Access Compliance Report

Public Rights-of-Way

Intersection ID: 10023924	Main Street: CONLAN_CR	Cross Street: N/A	Location: SW
ADA ID: 7B080EADE732	Ramp Type: Perp	Initial Pass/Fail: Fail	Overall Compliance: No
			Severity Score: 46.25

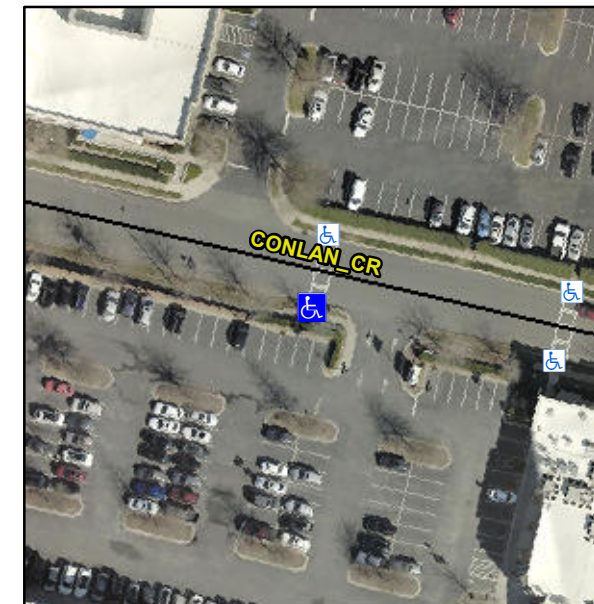
Not Found, R304.5.1, R304.2.2, R304.5.3

Compliance	Description	Data	Compliance	Description	Data
N/A	Ramp Length (in)	49.0	No	Ramp Slope (%)	9.9
No	Ramp Width (in)	46.0	No	Ramp XSlope (%)	9.5
N/A	Flare Type LT	N/A	N/A	Flare Type RT	N/A
N/A	Flare Slope LT (%)	N/A	N/A	Flare Slope RT (%)	N/A
N/A	Flare Traversable LT?	N/A	N/A	Flare Traversable RT?	N/A
N/A	Landing Length (in)	N/A	N/A	DWS Provided?	N/A
N/A	Landing Width (in)	N/A	N/A	DWS Contrast?	N/A
N/A	Landing Slope (%)	N/A	N/A	DWS Length (in)	N/A
N/A	Landing X Slope (%)	N/A	N/A	DWS Full Width?	N/A
N/A	Landing Curb? (Y/N)	N/A	N/A	DWS Offset (in)	N/A
N/A	Shared Landing?	N/A			
N/A	Gutter Ponding?	N/A	N/A	Gutter Slope (%)	N/A
N/A	Gutter Lip Ht (in)	N/A	N/A	Gutter X Slope (%)	N/A
N/A	Painted X Walk1?	Yes	N/A	Painted X Walk2?	N/A
	X Walk 1 Direction	To NE		X Walk 2 Direction	N/A
N/A	X Walk 1 Width (in)	103.0	N/A	X Walk 2 Width (in)	N/A
	X Walk 1 Slope (%)	4.5		X Walk 2 Slope (%)	N/A
	X Walk 1 X Slope (%)	7.2		X Walk 2 X Slope (%)	N/A

Remove & Replace Entire Ramp.
